LOCAL MOBILITY ANALYSIS
COTTONWOOD SAND MINE
County of San Diego, California
September 2021

ADDENDUM

DECEMBER 2022

The following changes have been made to the Cottonwood Sand Mine Local Mobility Analysis Report (September 2021) since the release of the Cottonwood Sand Mine Draft Environmental Impact Report (draft EIR):

Figure B

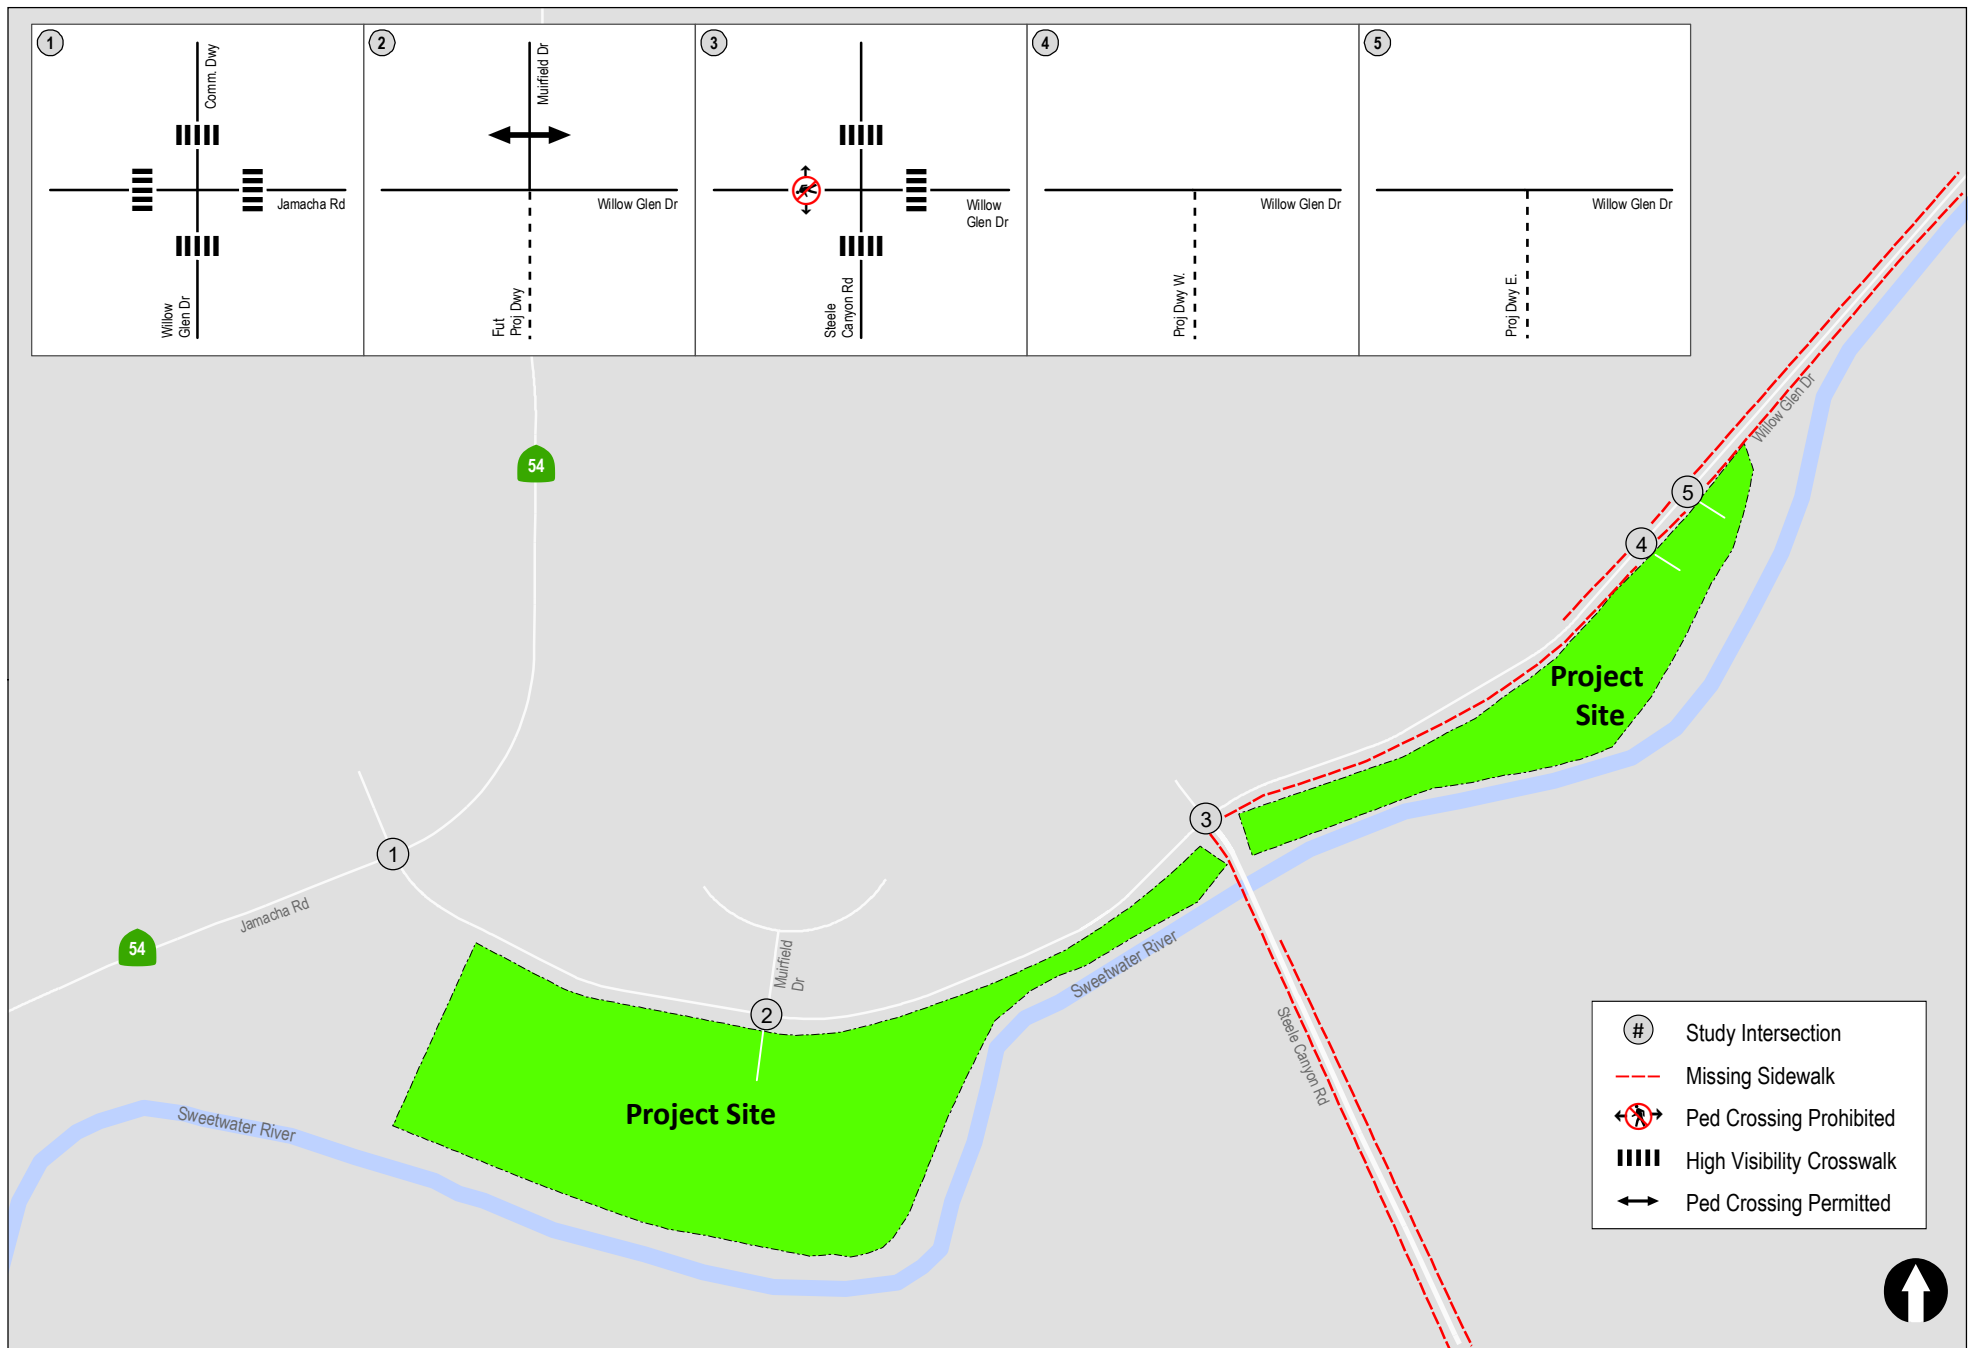
Section 5.5 Existing Pedestrian Conditions: An inventory of the existing pedestrian network was conducted for the study area. *Figure B* presents the existing pedestrian network in the project study area. This included documenting missing sidewalks, pedestrian barriers and crosswalks. As shown in *Figure B*, sidewalks are intermittently provided on both sides of Willow Glen Drive within the study area.

Existing pedestrian counts were conducted at every intersection in the study area during the commuter AM/PM peak hours as shown in *Appendix B*. *Figure C* shows the existing pedestrian counts that were observed at the project study intersections during the commuter AM/PM peak hours.
